Work Order ID 80718

Item Name: Crosstube Aft

DRAWING NO. D412-664-243	TITLE CROSSTUBE ASSEMBLY (412 HI AFT)	REV. E	DART AEROSPACE LTD ENGINEERING ORDER		D.E.O. NO. D412-664-243-E-1	SHEET NO. SHEET 1 OF 2	SCALE NTS
DRAWN	CHECKED	MFG. APPR.	APPROVED		DE APPR.		
DATE 11.03.31	DATE 11/03/31	DATE 11.03.31	DATE 11/03/31		DATE 11.03.31

DRAWING NO. D412-664-243	TITLE CROSSTUBE ASS'Y (412 HI AFT)	REV. E	DART AEROSPACE LTD ENGINEERING ORDER		D.E.O. NO. D412-664-243-E-2	SHEET NO. SHEET 1 OF 1	SCALE NTS
DRAWN 92	CHECKED ASS	MFG. APPR. E	APPROVED MP		DE APPR. H		
DATE 11.09.07	DATE 11.09.19	DATE 11.09.19	DATE 11.09.19		DATE 11.09.19

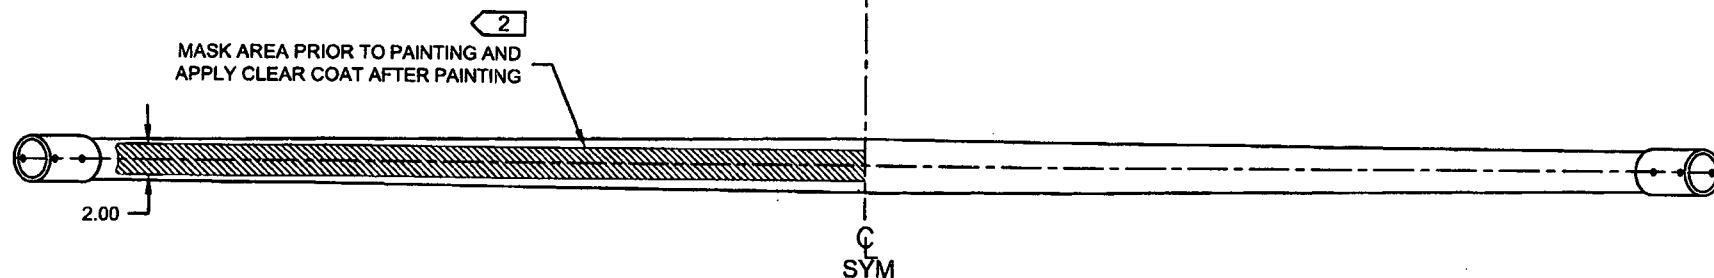
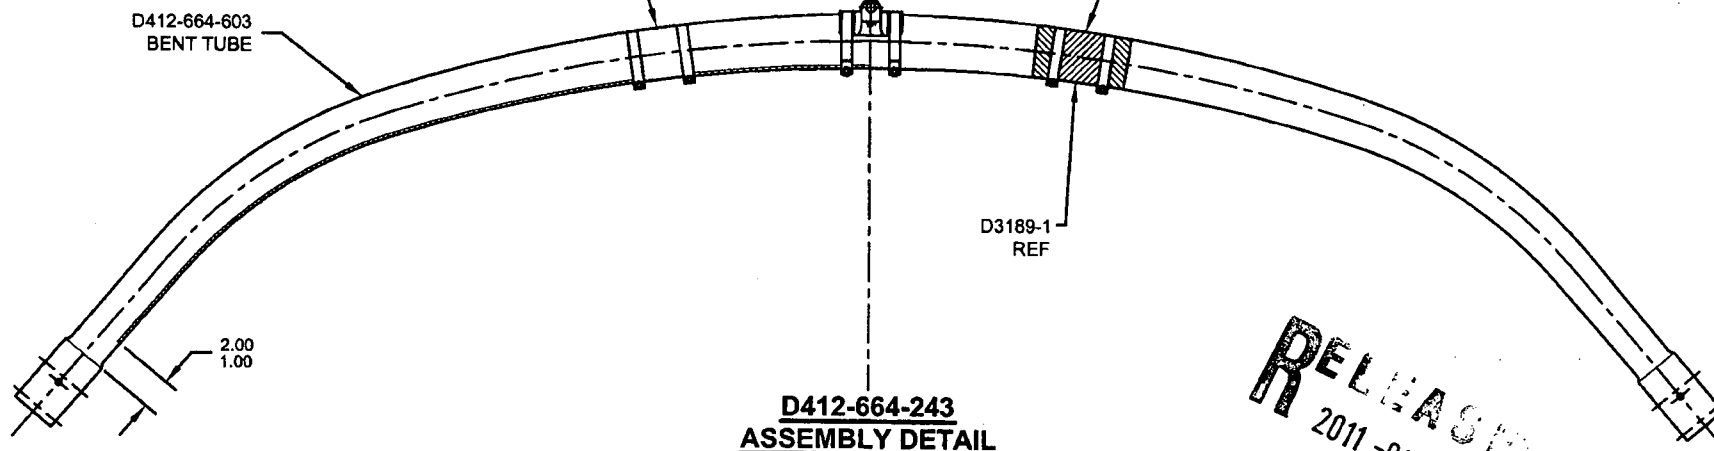
PURPOSE:

REMOVED ABRASION STRIP IN FAVOR OF A THIN LAYER OF PROSEAL 890.

IS:

D3189-1 CHAFING SHIELD (1, INSTALLED OVER PROSEAL 890)
MS21920-28 CLAMP, 2X
2 PL

WAS:

D2856-600-1009 ABRASION STRIP
D3189-1 CHAFING SHIELD (1, INSTALLED OVER ABRASION STRIP)
MS21920-28 CLAMP, 2X
2 PL

CRUSHING OF D412-664-243

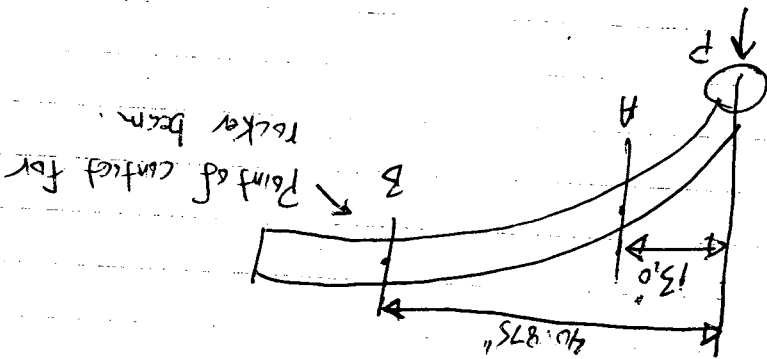
Acceptability of 8% CRUSHING AT END OF BEAD

Point A: $CD_1 = 2.961$, $CD_2 = 2.522$

CRUSHING = $(2.961 - 2.522) / (2.961 + 2.522) = 8\%$
 $I = 1.676 \text{ in}^4$ (from AutoCAD)
 $CD_1 = 3.307$, $I = 4.613 \text{ in}^4$

A: $I = M_c / I = P \times 13 \times 2.961 / 2 \times 1.676 = 11.484 \cdot P$
 $B: = P \times 40.875 \times 3.307 / 2 \times 4.613 = 14.651 \cdot P$

M.S. = $14.651 / 11.484 - 1 = 0.27$

∴ Tube will break at rocker beam contact before area of 8% crushing, 8% crushing in area at end of tube
